2.12 Station Electrical Systems

The information in this section of the reference ABWR DCD, including all subsections, figures and tables, is incorporated by reference with the following departures.

Figure 2.12.15 Instrument and Control Power Supply

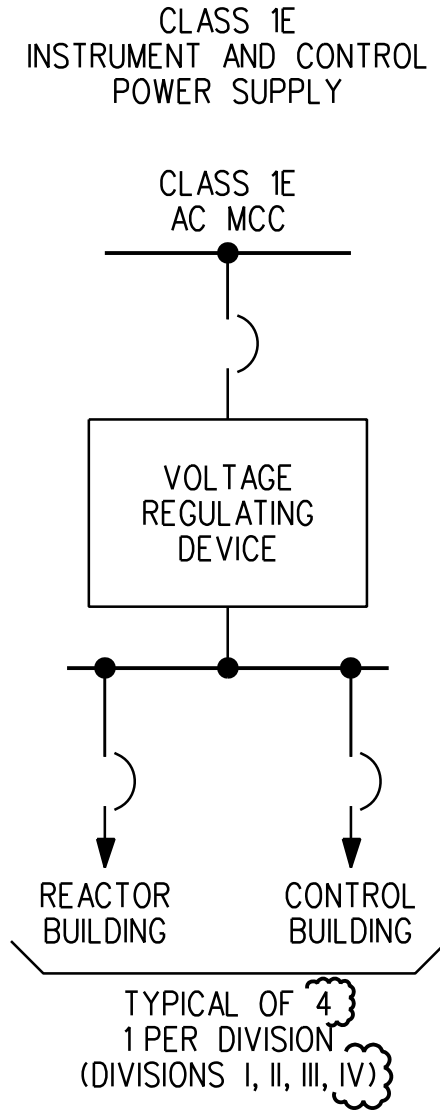
STD DEP T1 2.12-2 (Figure 2.12.15)

STD DEP T1 2.12-2

The Class 1E Instrument and Control Power Supply consists of ~~three~~ four divisions (Division I, II, ~~and III, and IV~~) of interruptible power supplies with their respective distribution panels. Each Class 1E power supply provides interruptible, regulated AC power to Class 1E circuits which do not require continuity of power during a loss of preferred power (LOPP).
